April 30, 2014

Re: Revision No. 27  
KRSB-8603

Per your letter of April 24, 2014, enclosed are three CD's in electronic format. Individual comments are set forth below followed by Dakota Westmoreland's responses and a list of the revised information.

Exhibit 2.10.2  
Page 8  
Tech. Def.  
July 15, 1986

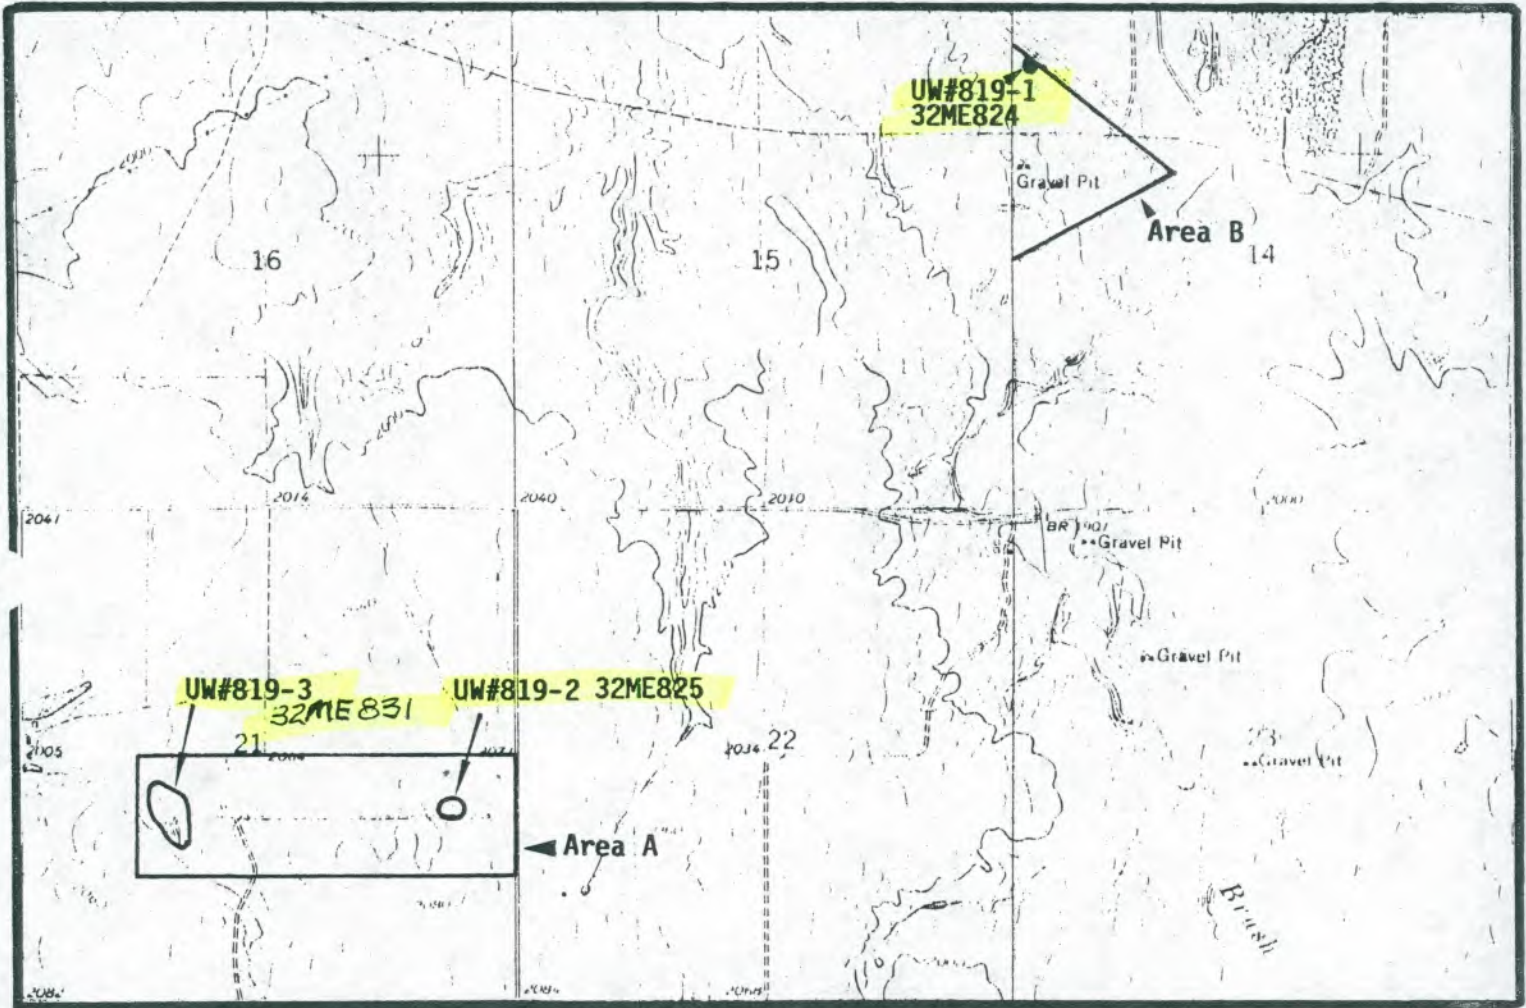
- c) The listing for site 32ME831 in the Cultural Resources Inventory table indicates that the site was determined to not be significant in a letter from the SHPO dated July 9, 1986. However, this letter does not include a significance determination for this site. Please reference the correct significance determination for site 32ME831.

- Information regarding the “re-naming” of this site (and sites 32ME824 and 32ME825) was added to the first page of Section 2.10 with the April 11 submittal. Site 32ME831 is listed as 32ME819 on the July 9, 1986 letter from the State Historical Society. I have attached a copy of this letter, with my notes and the mapped page from the original cultural resource report (Exhibit 2.10.3, Appendix 1) indicating the changes. Recorded site 32ME819, as indicated in the letter, is actually in Section 14, T. 143N., R.88W., and permit KRSB-8802. The SHPO document date is correct.
